Petrotomics Company

Reference: Alternate Concentration Limits Application - Response to open issues 1, 4, and 5
- Source Material License SUA-551

PETROTOMICS TAILINGS FACILITY
APPLICATION FOR ALTERNATE
CONCENTRATION LIMITS
SOURCE MATERIAL LICENSE SUA 551
RESPONSE TO NRC OPEN ISSUES 1, 4, AND 5

RESPONSE TO NRC OPEN ISSUES 1, 4, AND 5

PETROTOMICS COMPANY
Figure 1-1
Cadmium in Proposed POC Wells

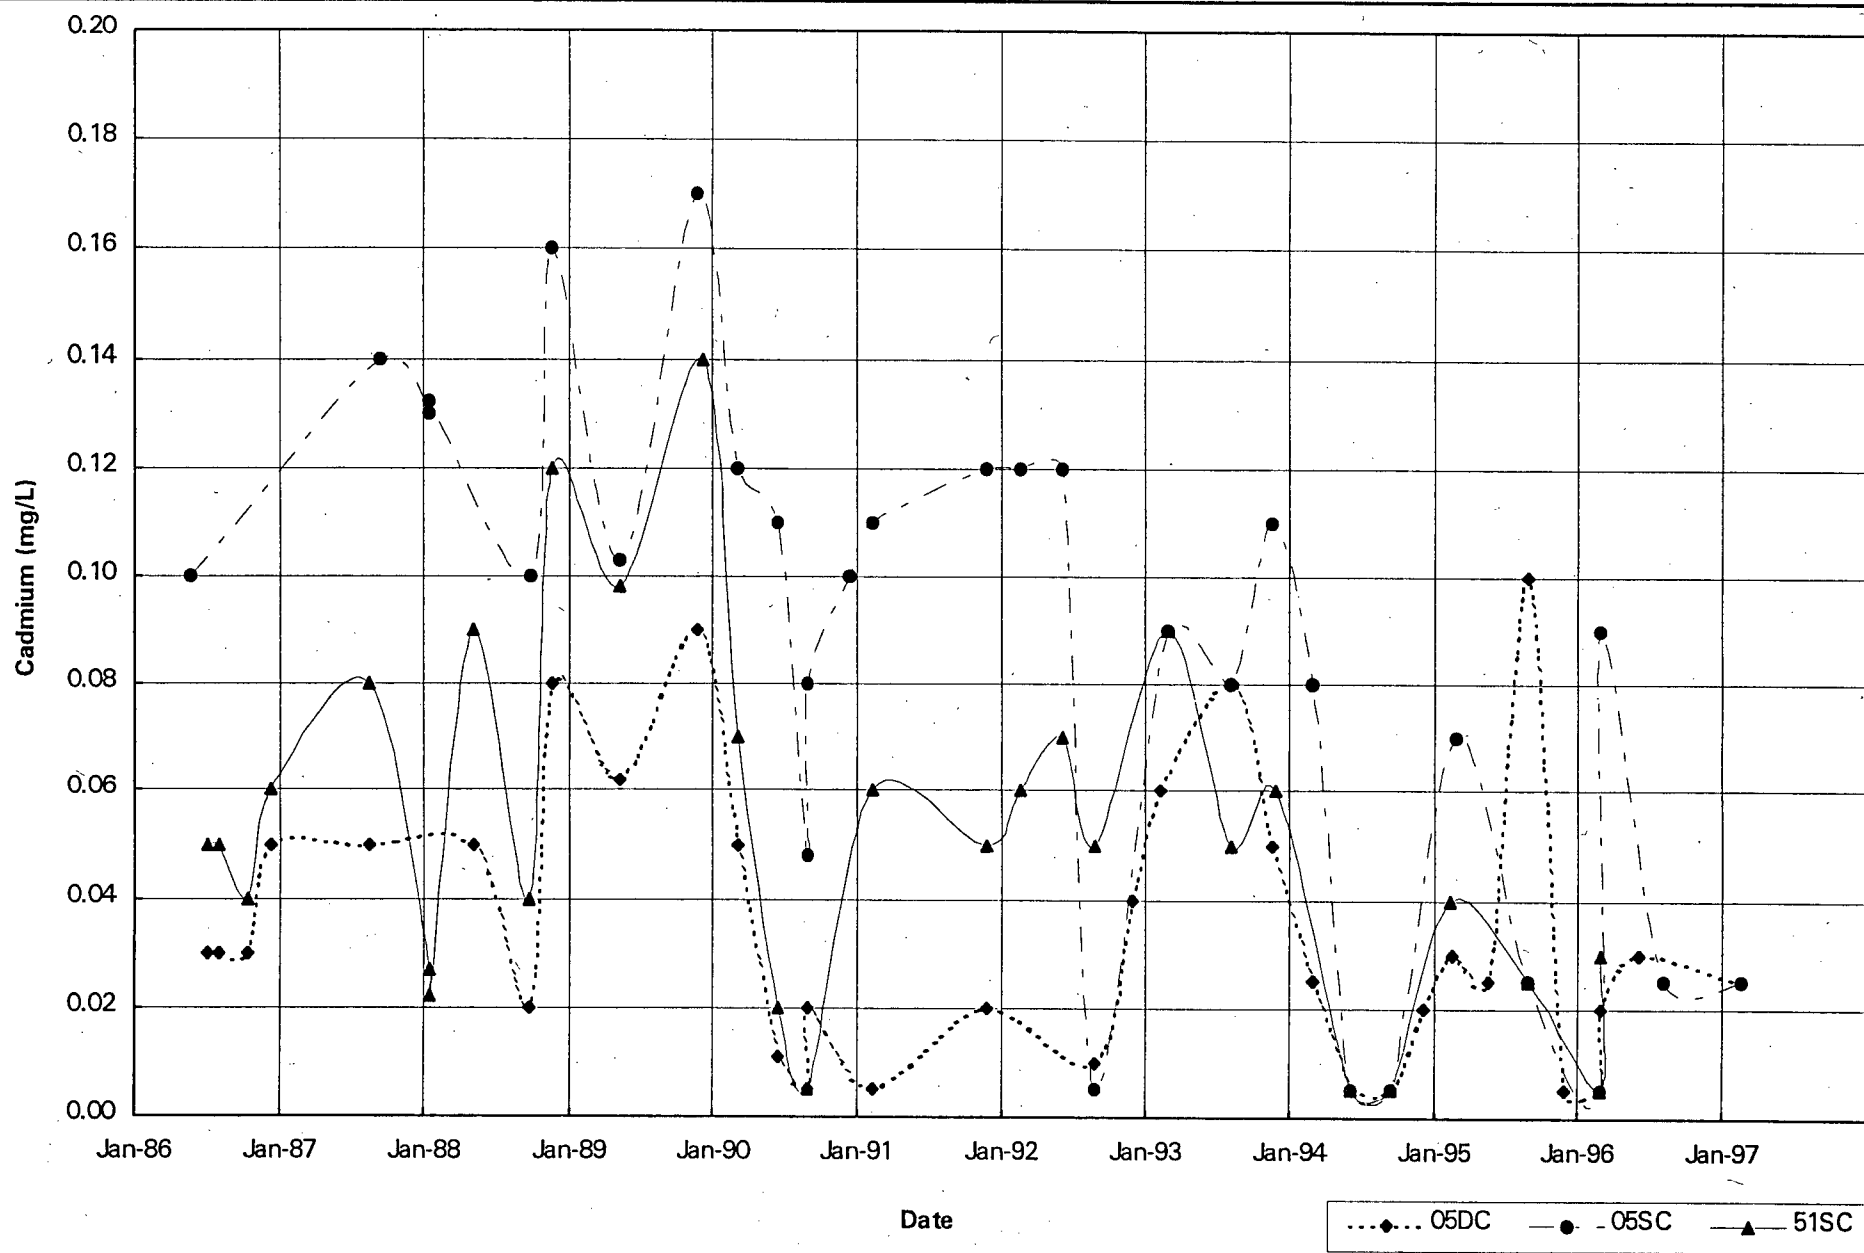
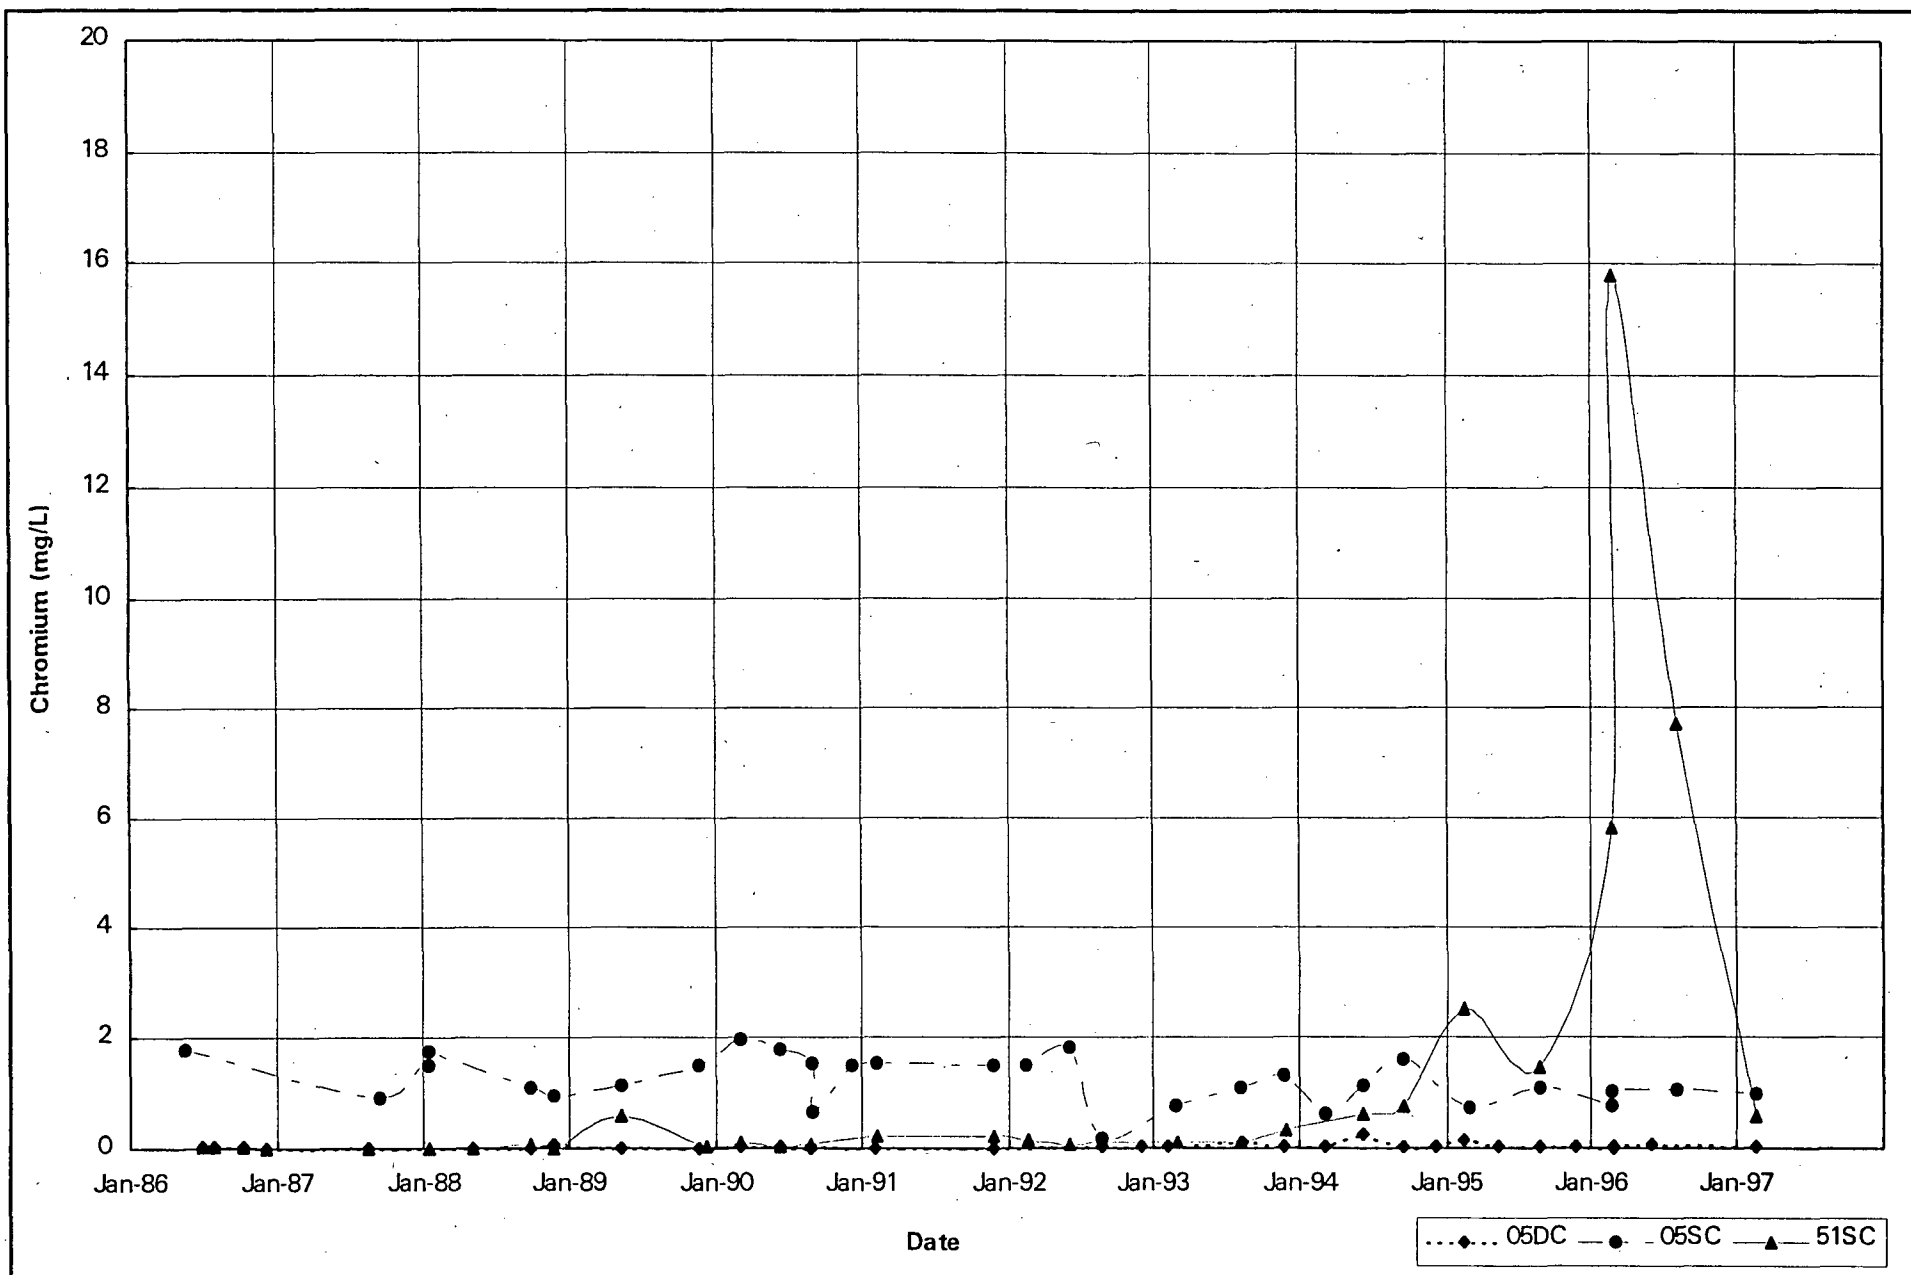
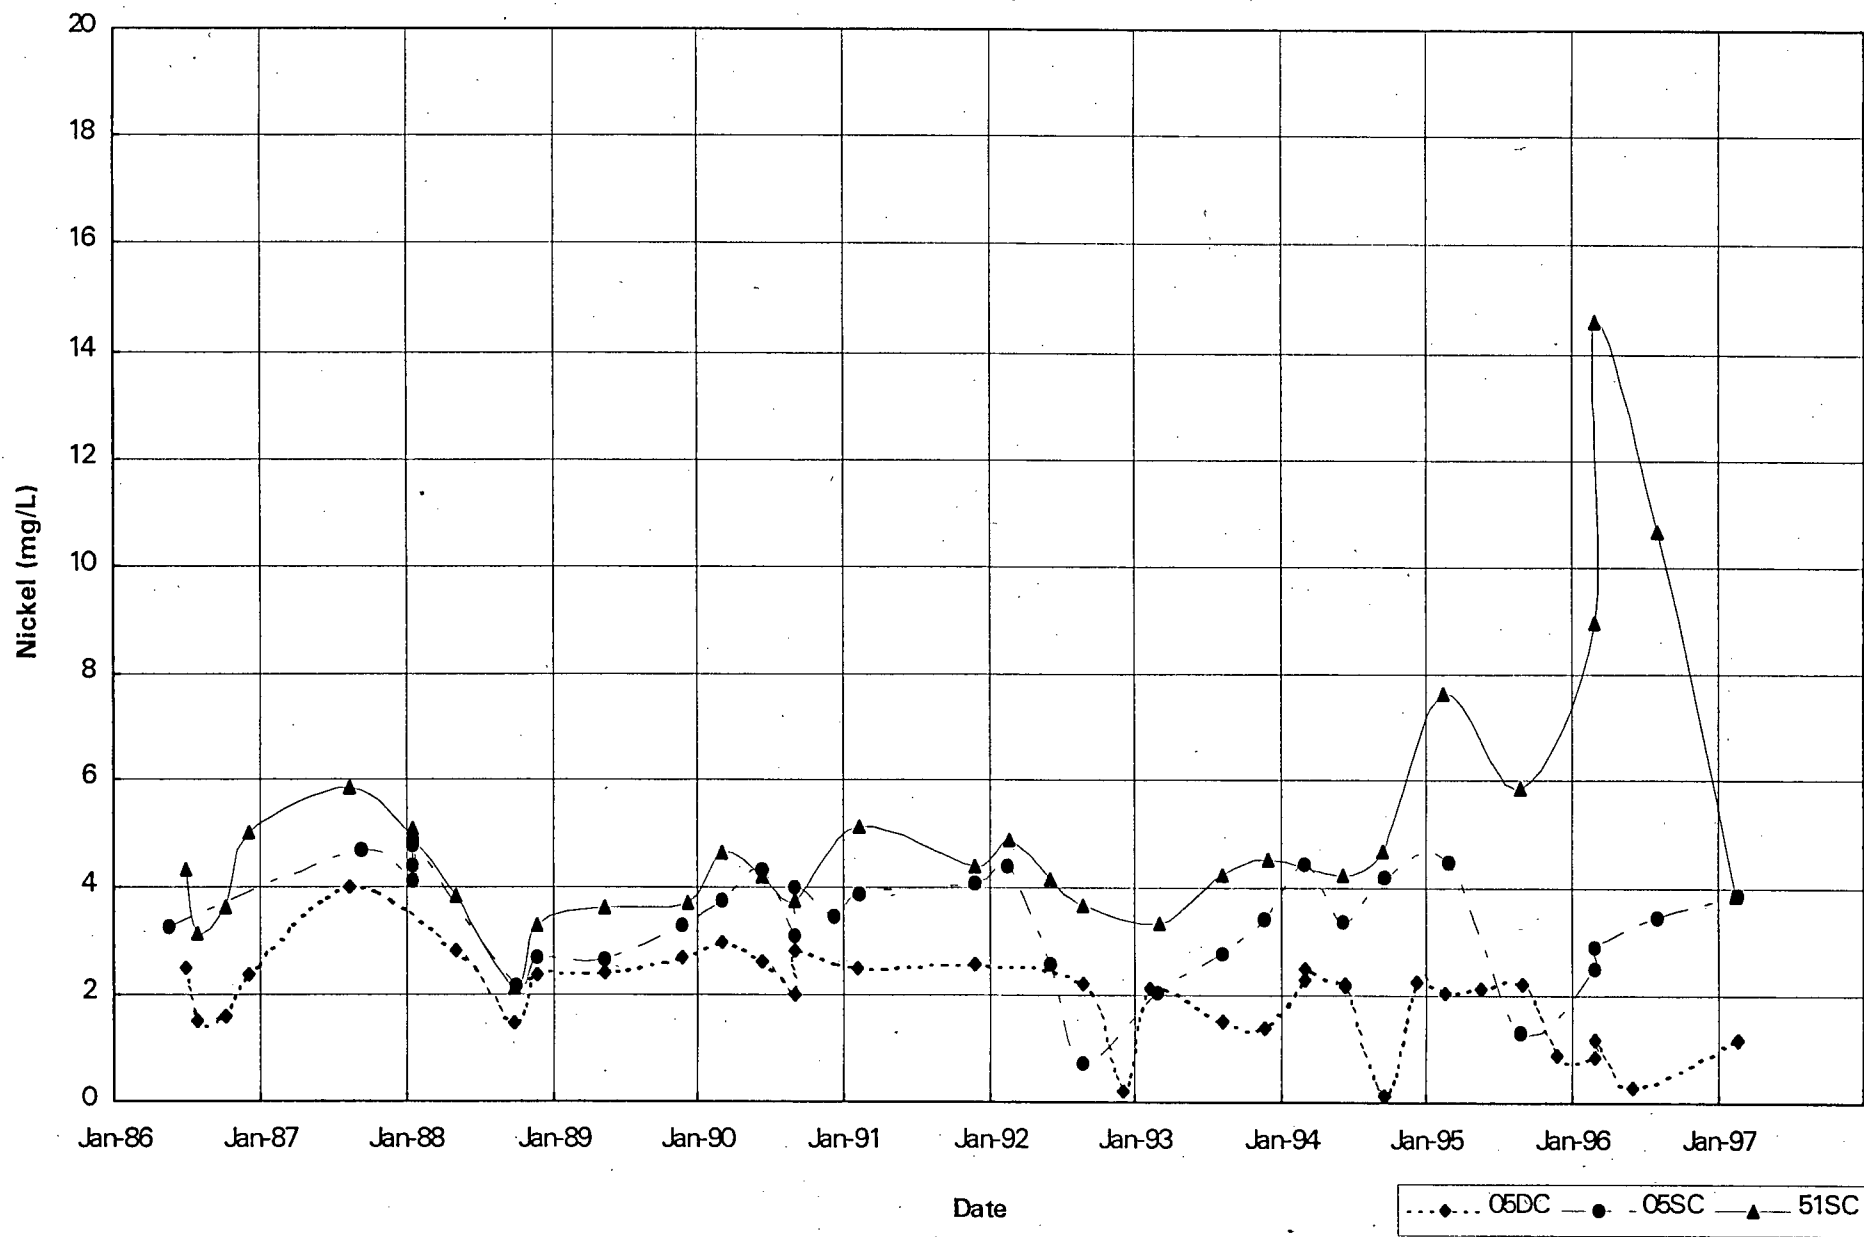
ACTION NEEDED: Petrotomics should propose ACL values for hazardous constituents of concern which are ALARA. These values should be based on an assessment of constituent concentrations levels achieved to date. Petrotomics should use data from wells outside the tailings impoundment to select site ACLs and should exclude well 12DC from consideration as a POC.

Concentrations of constituents of concern in the proposed POC wells are illustrated as a function of time in Figures 1-1 through 1-9. Sulfate concentrations, chloride concentrations, and pH were also evaluated for these wells as a function of time (Figures 1-10 through 1-12). A tabular listing of constituent concentrations for POC wells 5SC, 5DC, and 51SC is provided in Attachment 1. The concentrations of most constituents essentially stabilized by January 1995. The exceptions were chromium and nickel concentrations in well 51SC, which exhibited a temporary, sharp increase during 1996 (Figures 1-2 and 1-4).

The 95% upper confidence limit (UCL_{95}) values calculated about the mean for chromium and nickel were anomalously high because of the previously noted concentration trend observed in well 51SC during 1996. These concentrations are unlikely to be representative of water that will be sampled by the POC wells from this time forward. Because these values are clearly anomalous and would result in higher ACLs, the statistical evaluation was repeated for chromium and nickel, excluding the three relatively high concentration values observed in 1996 (Table 1-2). Excluding the anomalously high values allows the incorporation of the most recent trends in the data, and results in lower, more conservative ACL values for chromium and nickel.
